PRODUCT ADVISORY

Data Sheet Specification Correction for Listed Intersil Products

**Refer to:
PA14035**

Old POD P3.064 (changes in red) – PA14035

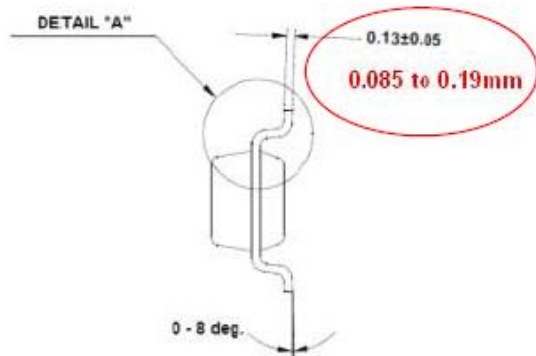
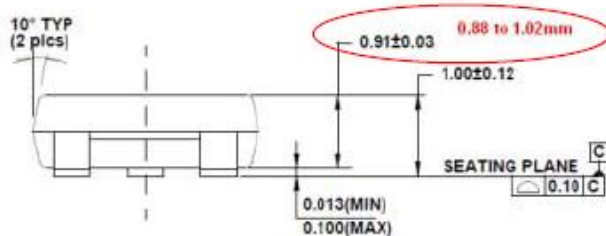
This advisory is to inform you that Intersil has made corrections to the POD (Package Outline Drawing) referenced in the data sheet specification for the listed products. The updates to the POD correct the thickness (height) of the package body. The old POD is marked up below to identify the changes. There have been no changes to the package or product itself. The updated data sheets are available on the Intersil web site for the respective products.
